RE: RE-ZONING AND DEVELOPMENT PERMIT APPLICATION: 1042-1044 RICHARDSON STREET

Attn: City of Victoria Planning staff (Alec Johnston):

Responses and actions taken in response to the review are addressed to each individual department in this letter, in the same order that they were presented to the applicant in the Application Review Summary (Dated October 20, 2020 and January 25, 2021). In addition to these responses, and revisions to plans, the following supplementary documents have been produced and are included in re-submission:

A1.01

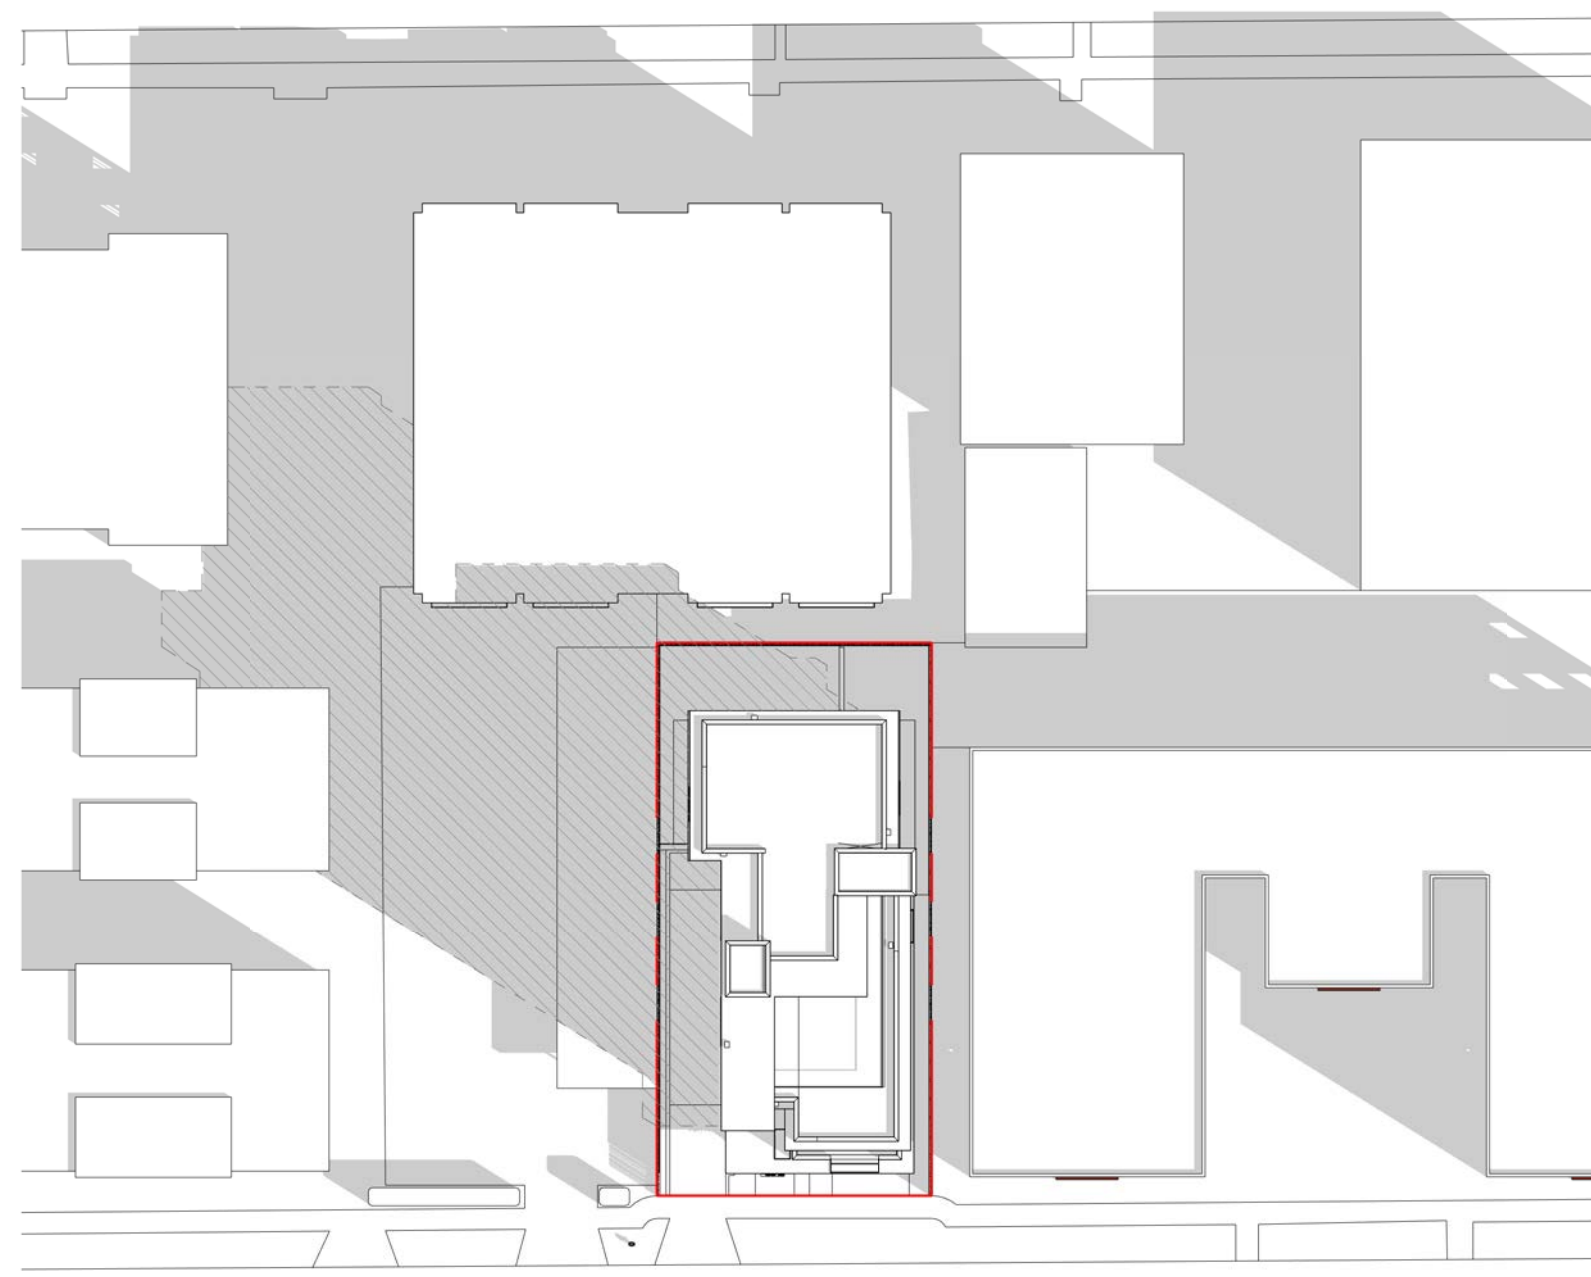
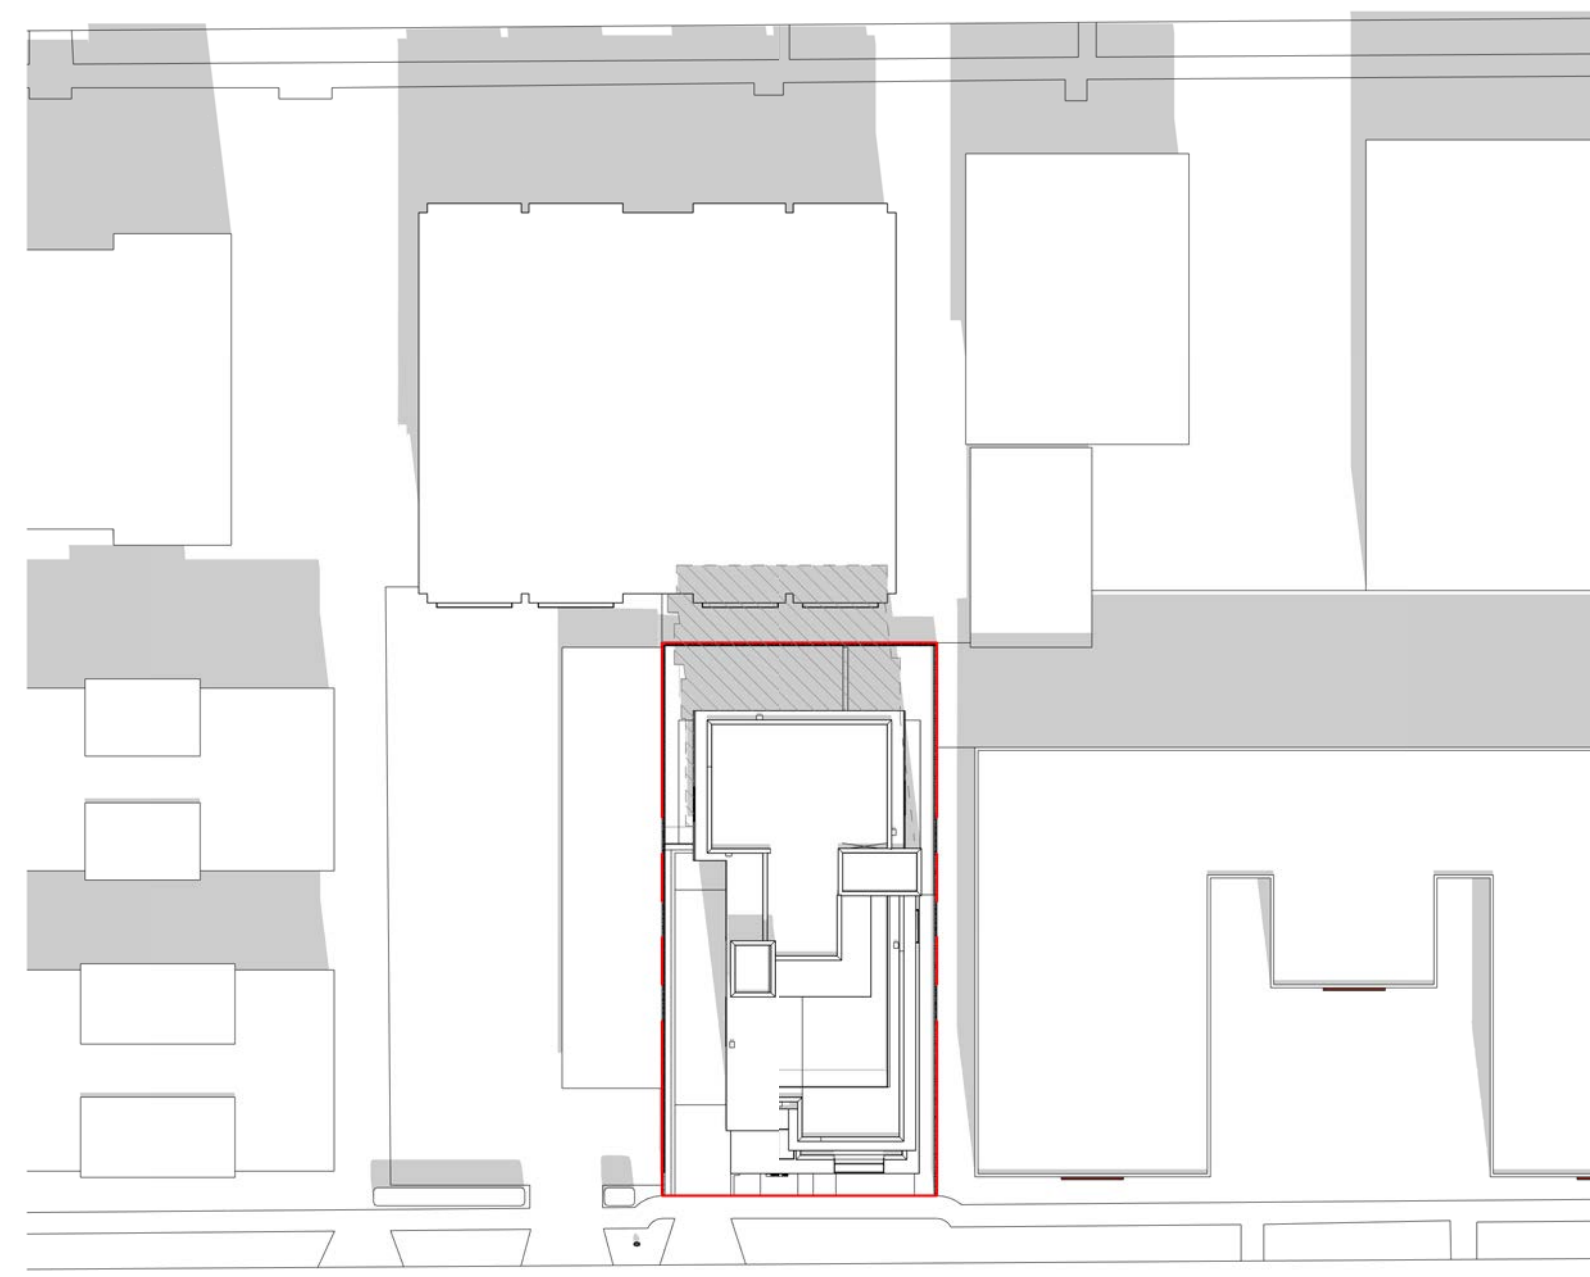
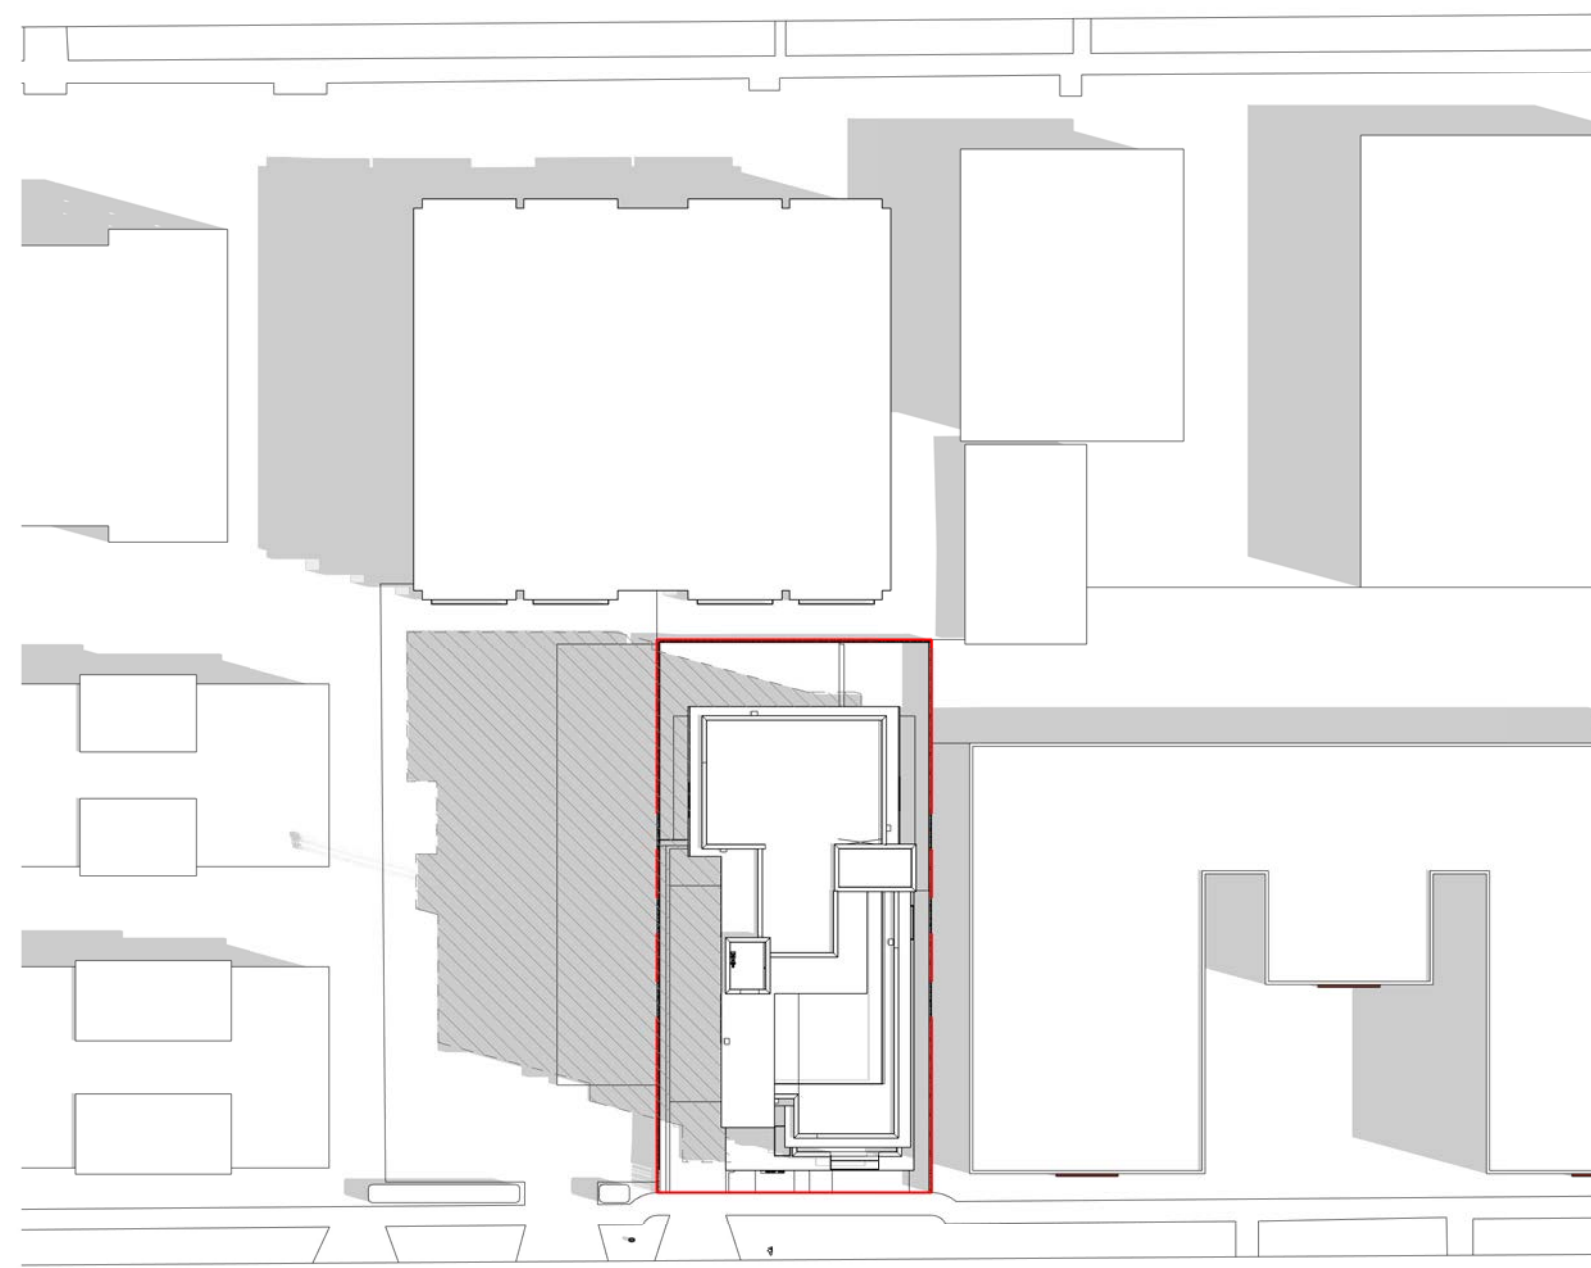
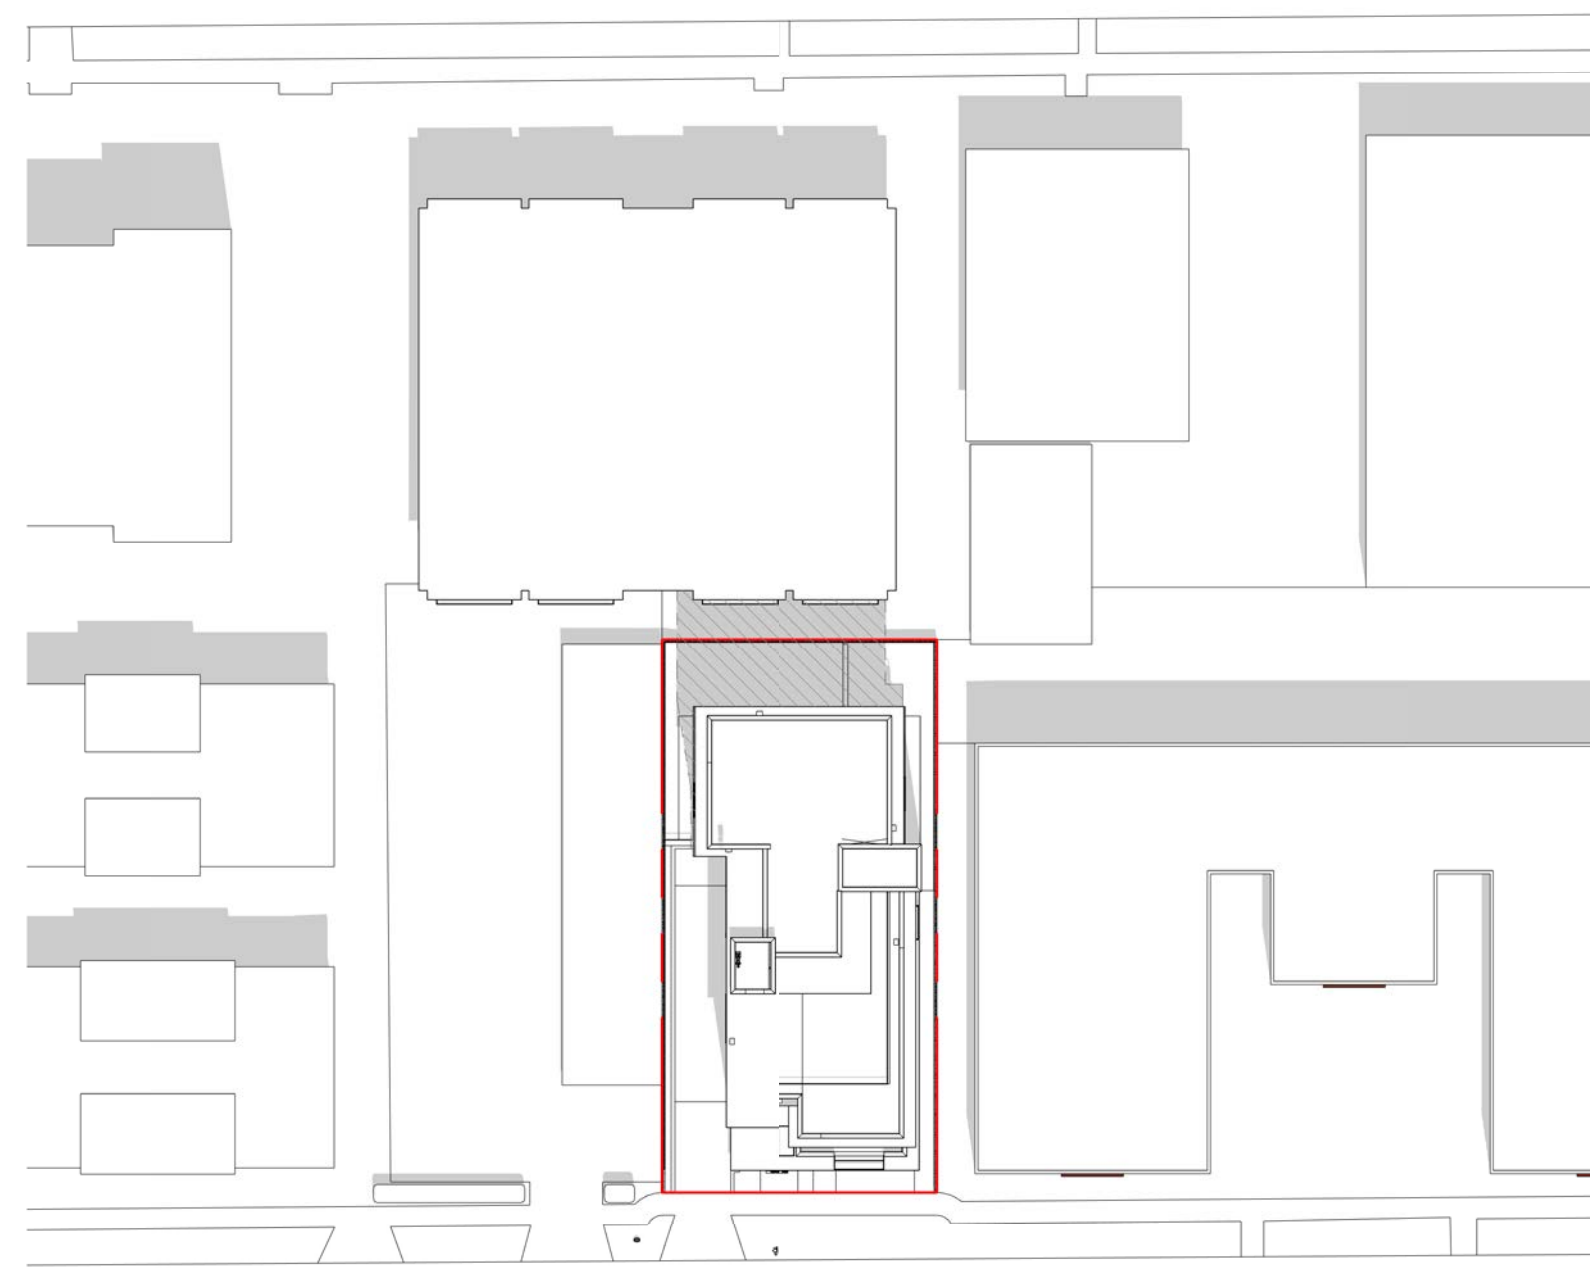
Condition #4: *Please provide a 3D shadow analysis to help assess the shadowing impacts of the proposed building.*

Applicant Response / Actions Taken: A 3D shadow analysis has been completed and is included in the revised plan set. Placing the roof deck centered on the rooftop, and away from the northern property line, reduces shadowing impacts on neighbouring properties.
